**TO:** DEVELOPMENT REVIEW BOARD **DATE:** August 21, 2003  
**FROM:** CURRENT PLANNING SERVICES  
**SUBJECT:** CASE 35-DR-2003  
**REQUEST:** Approve site plan, landscape plan, and elevations for a restaurant remodel and additional retail space.  
**PROJECT NAME:** Scottsdale & Shea  
**LOCATION:** Shea Boulevard east of Scottsdale Road

# **Stipulations for Case: Scottsdale & Shea 35-DR-2003**

Site Plan Worksheet

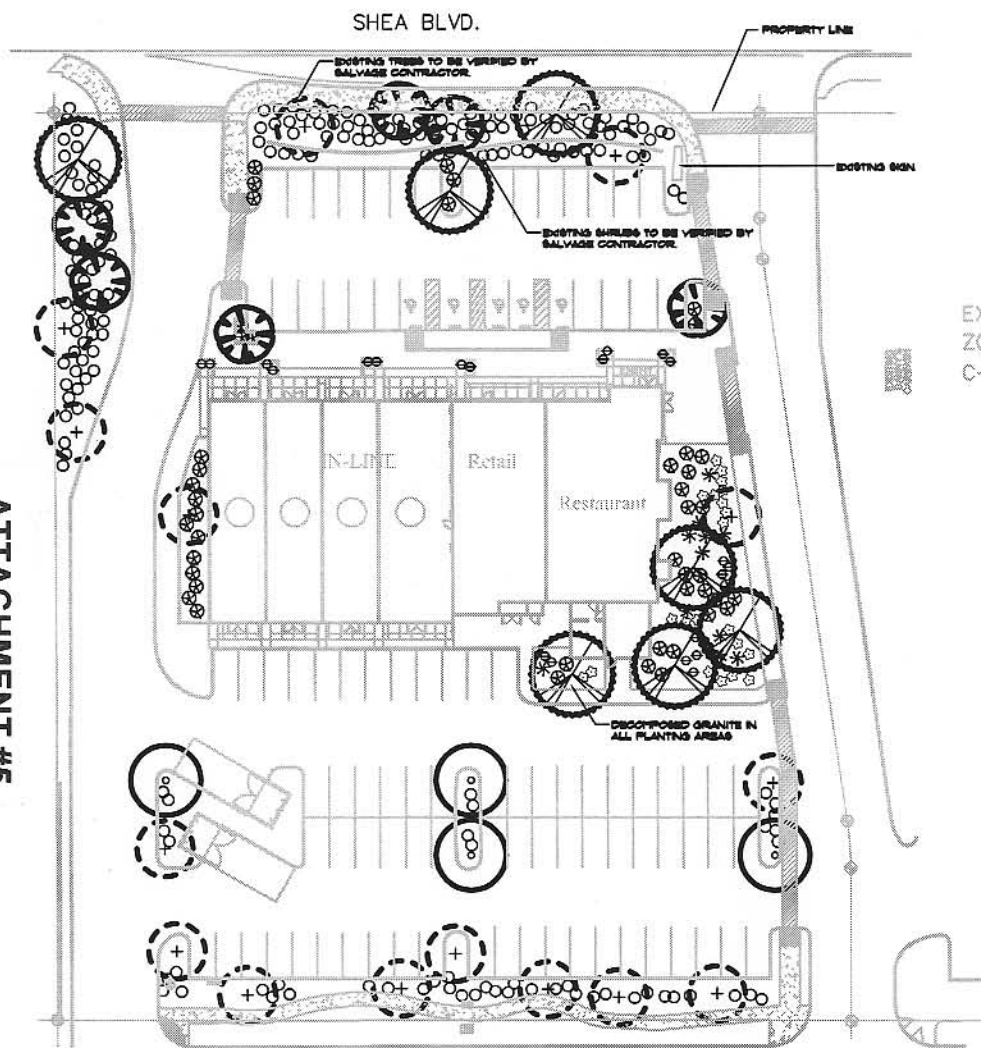
- B. The developer shall provide an accessible ramp at the end of the north-south accessible pedestrian route, adjacent to the east property line, at the southeast corner of the site to continue the accessible route the east.

- C. The developer shall revise the site plan so that a minimum of twenty-feet (20'-0') of landscape setback is provided from the property line to the parking stall over hang (in the event of a sixteen-foot (16'-0") stall with a two foot (2'-0") overhang) or to the parking stall curb (in the event of an eighteen-foot (18'-0") stall).

- D. The required parking lot landscape calculations shall be revised to correctly reflect the number of parking stalls provide on site.
- E. If provided, the parking lot over hang shall not be counted toward the parking lot landscaping or open space.

Preliminary Landscape Plan

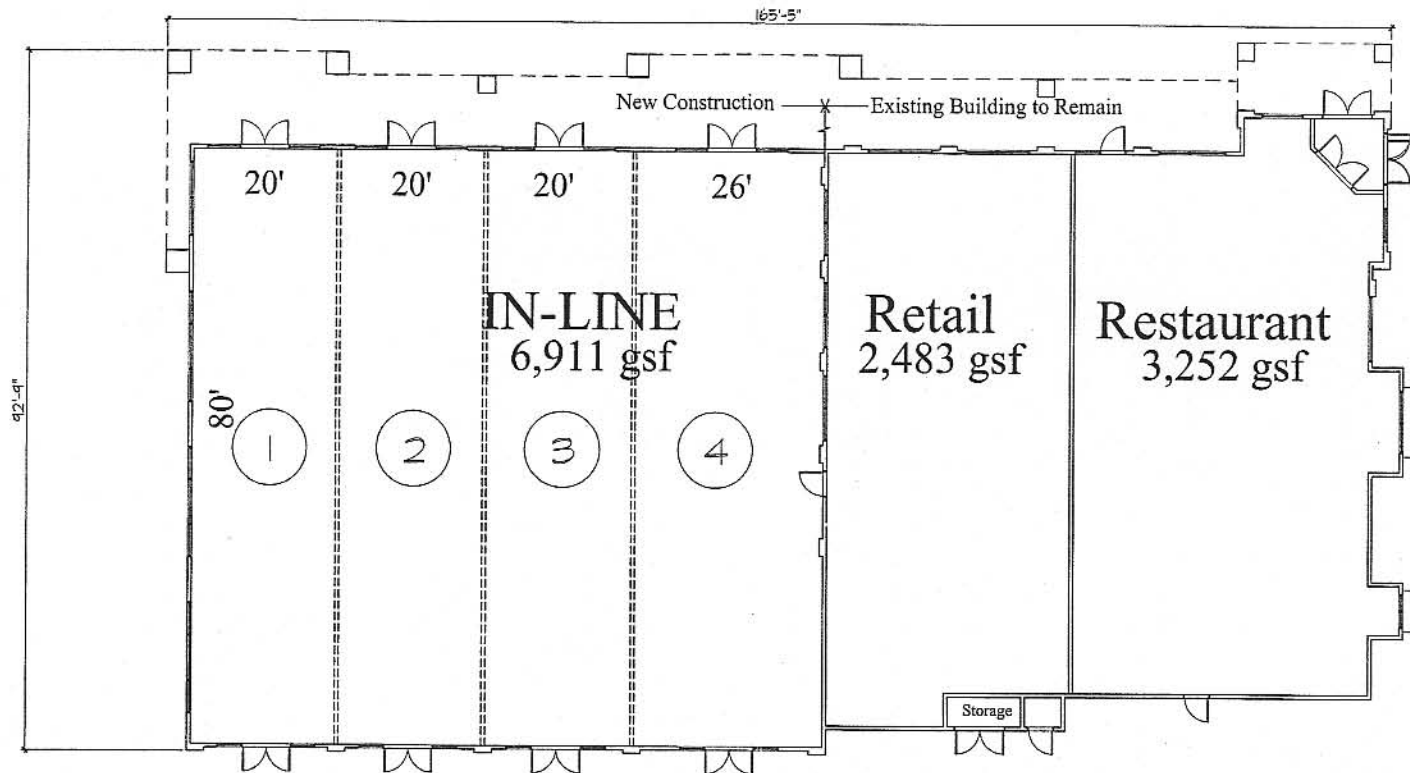
10. The remainder of the new trees shall be a minimum of two-inch (2") caliber single truck or one-inch (1") average multi-truck trees.
11. The applicant shall increase the proposed planter sizes and possible locations found along the north façade to allow for the installation of canopy trees within the planters.

12. The applicant shall add an additional planter at the southwest corner of the in-line shops and plant a canopy tree and shrubs.
